Agenda  
Village of Glen Ellyn  
Special Meeting  
Monday, December 18, 2017  
7:00 PM  
Glen Ellyn Civic Center, Room 301

**H. Taylor Avenue Pedestrian Tunnel Project (Professional Engineer Daubert) (Trustee Kenwood)**

**1. Motion to increase the appropriation for Phase II engineering services associated with the Taylor Avenue Pedestrian Tunnel Project provided by Alfred Benesch & Company in the amount of \$34,105 for a revised total appropriation of \$189,565 to be expensed to the Capital Projects Fund. 2. Motion to authorize the Village Manager to execute Change Order No. 2 to the Phase II engineering services agreement with Alfred Benesch & Company for the Taylor Avenue Pedestrian Tunnel Project for additional investigations and analyses in the amount of \$34,105 resulting in a revised total fixed price of \$189,565.**

**From:** O'Connor, Michael  
**To:** [Richard Daubert](#)  
**Cc:** [Keaschall, Andrew](#)  
**Subject:** Village of Glen Ellyn Taylor Ave. - Supplement to Address New Conditions  
**Date:** Thursday, December 07, 2017 10:13:06 AM  
**Attachments:** [10507 - Glen Ellyn Scope Change Spreadsheet.pdf](#)  
[Glen Ellyn Scope Change Attachment Exhibits.pdf](#)  
[

**PLAN VIEW**  
(After completion of path tunnel project)

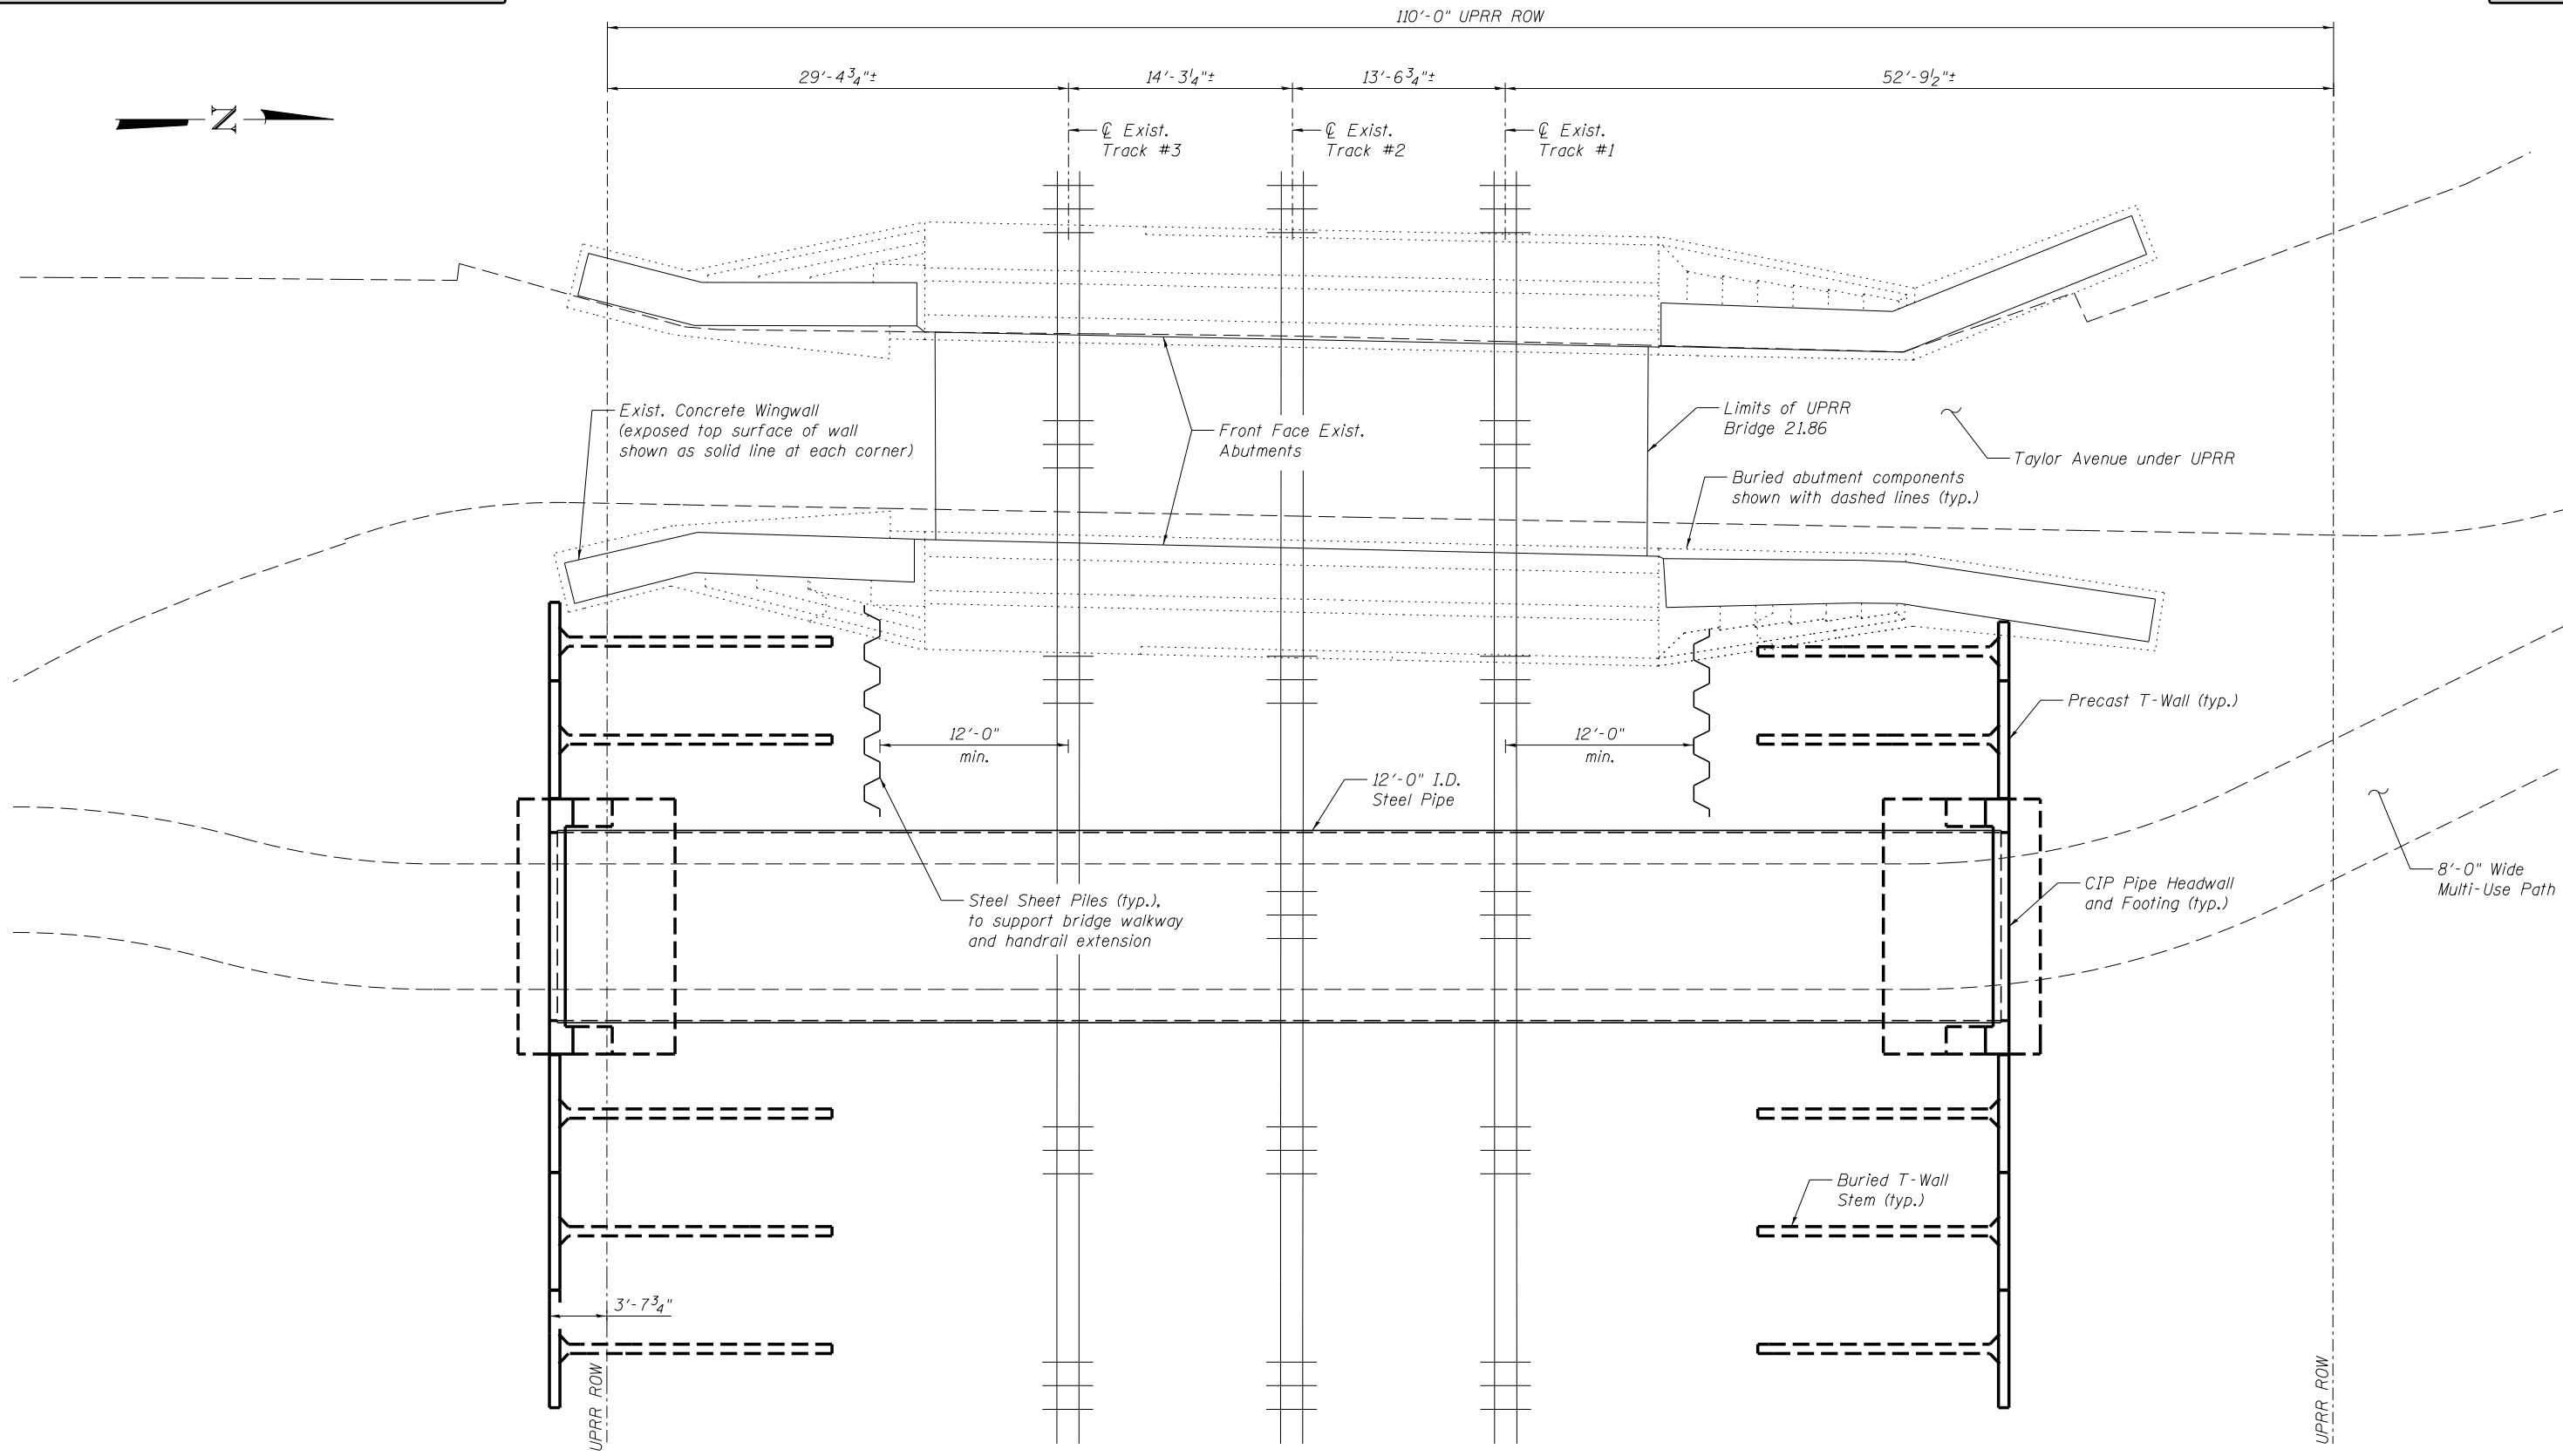
**Sheet 2: Existing Condition (After Completion of Path Tunnel Project)**

- This sheet shows a plan view of the currently proposed final condition at the site after completion of the path tunneling project.
- Note that on the south side, the proposed front face of the T-Wall is around 3'-8" off the UPRR ROW. This is in line with the existing UPRR bridge wingwall, which extends off the UPRR ROW. To keep the T-Wall entirely on UPRR ROW, the temporary sheeting would need to encroach within the 12'-0" minimum track offset that has been prescribed to provide adequate space for the T-Wall stems (see Sheet 4 for more discussion).

PLAN VIEW  
(During removal and construction of future widened abutments)

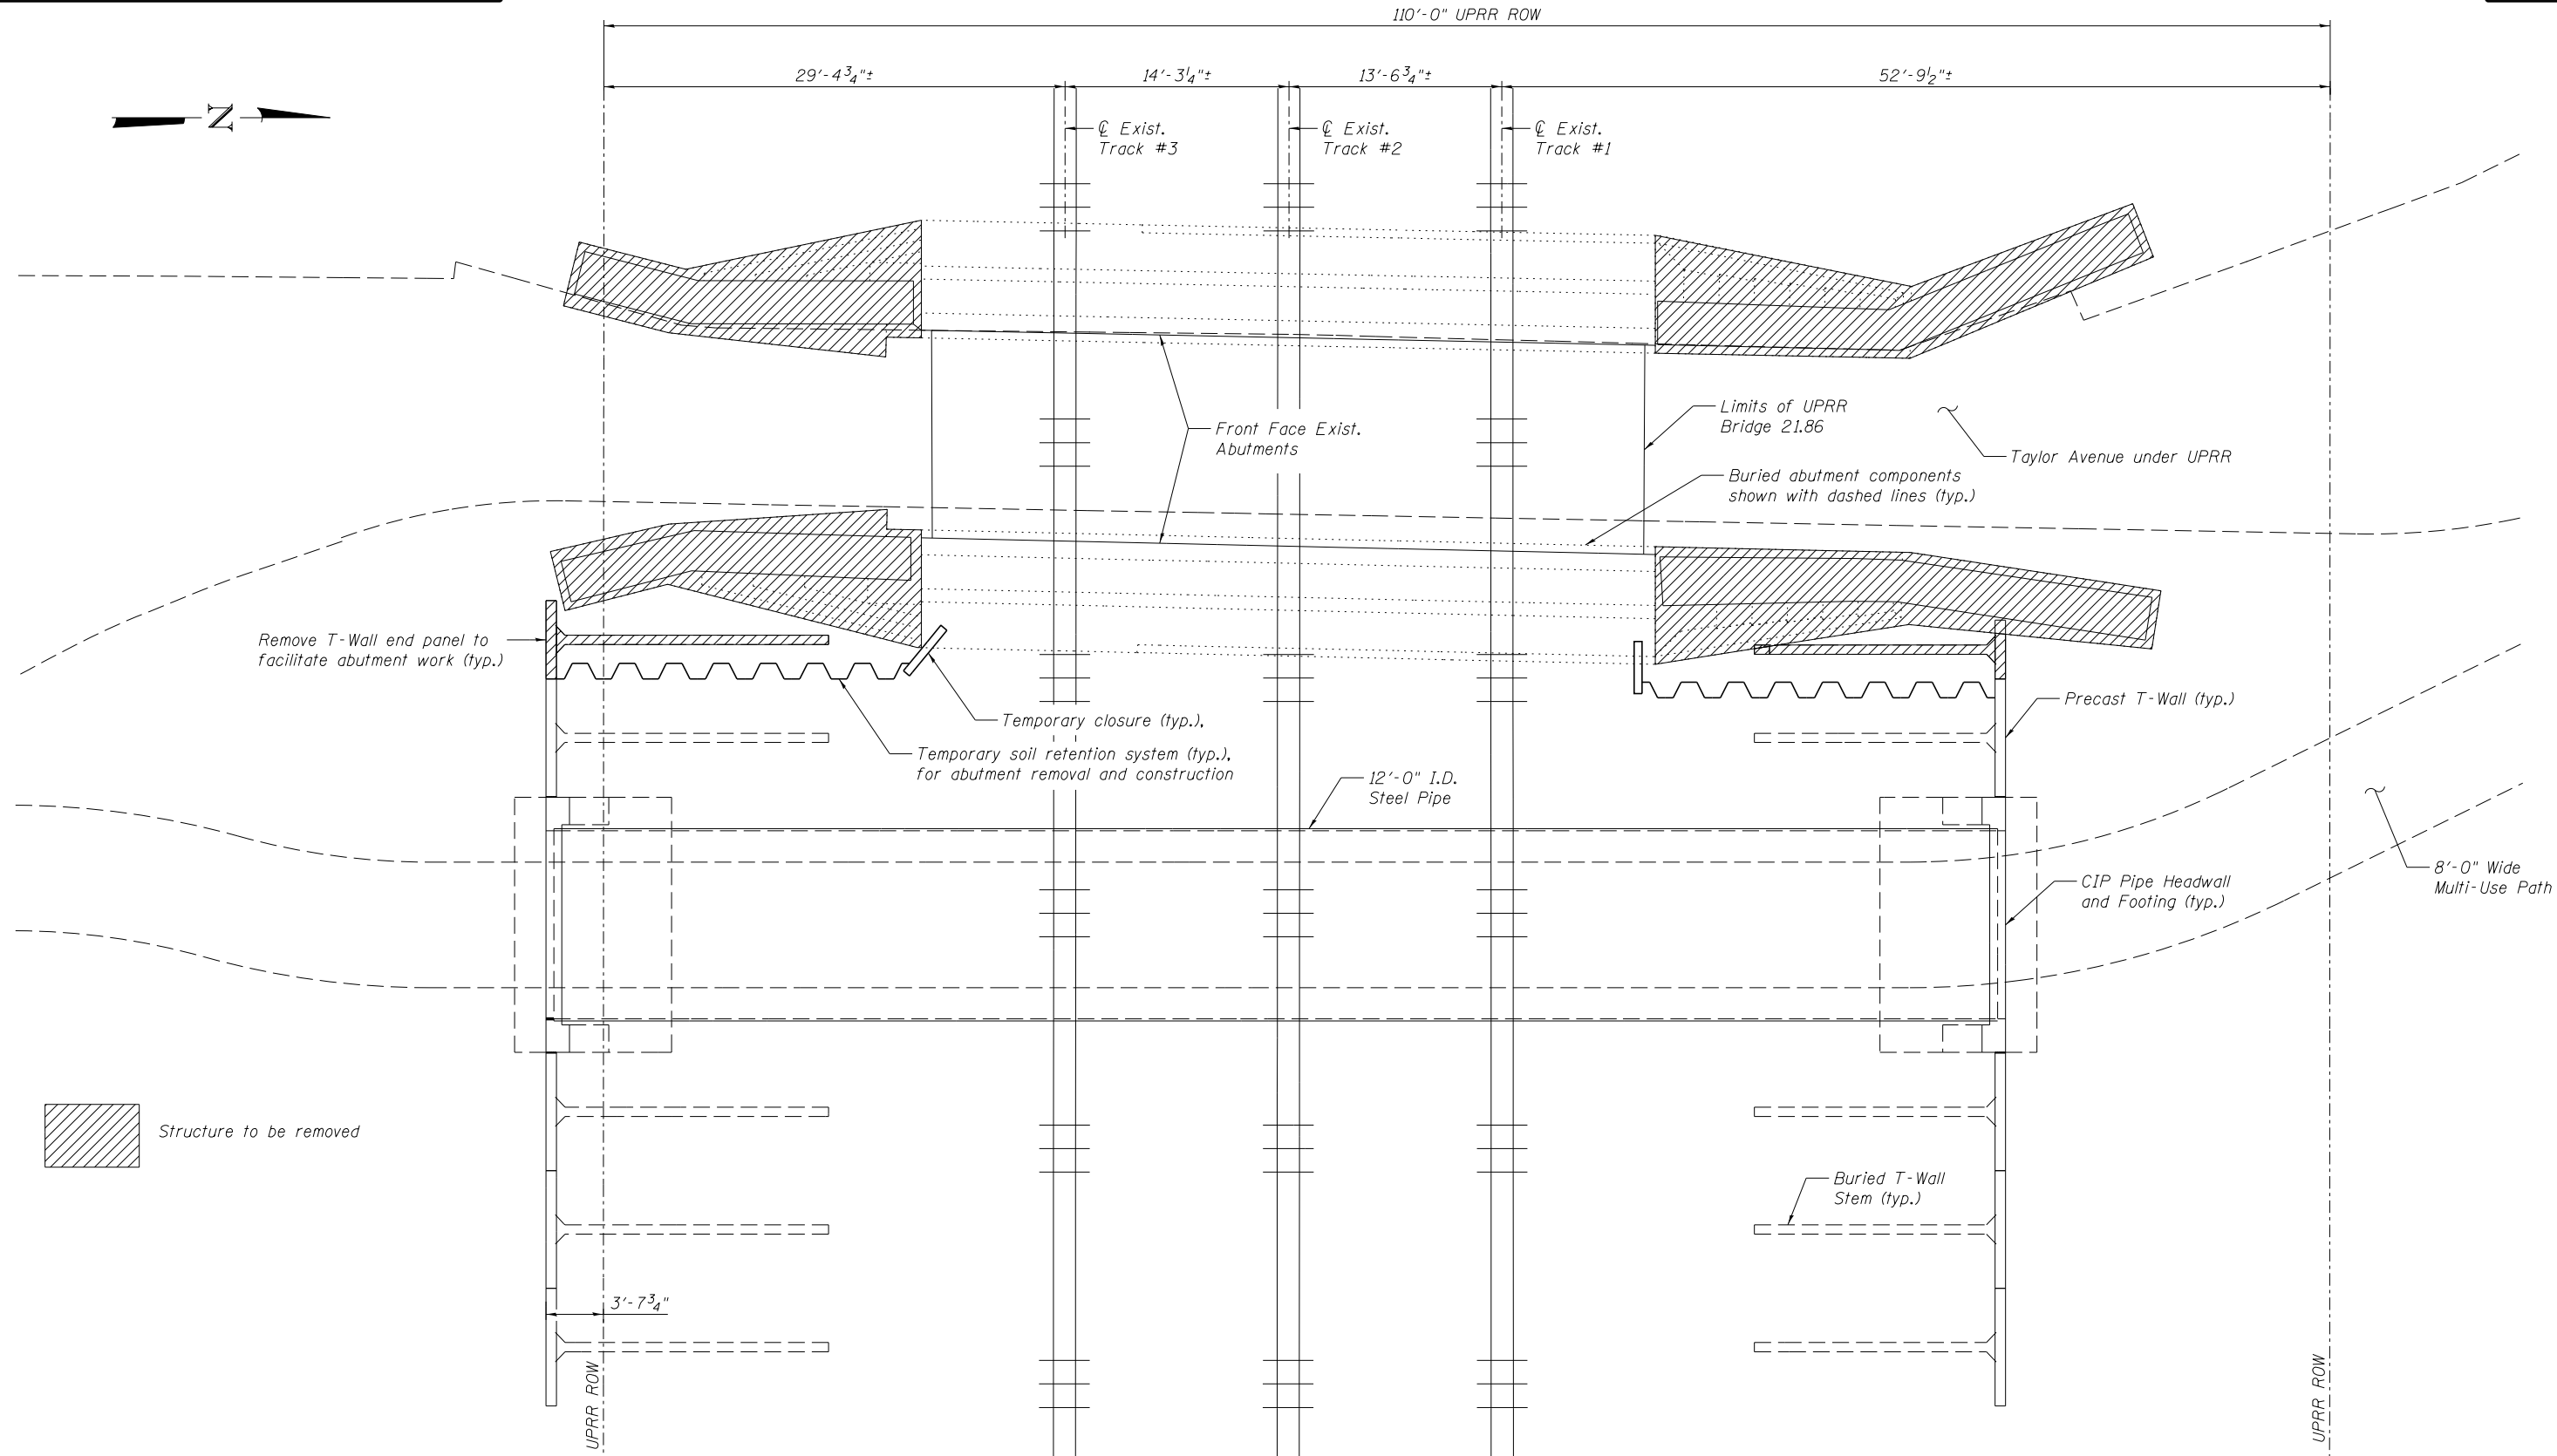
**Sheet 3: Future Temporary Condition for Abutment Widening**

- This sheet shows one concept for construction staging to support widening of the existing bridge substructure. It assumes the bridge will be widened via full removal of the existing concrete/masonry abutments or wingwalls.
- A line of temporary sheeting may be installed perpendicular to the track between T-Wall stems to allow for excavation and removal of the existing bridge abutment or wingwall.
- The stack of T-Wall units directly adjacent to the existing bridge wingwalls will be removed to make room for the new bridge abutment/wingwall.
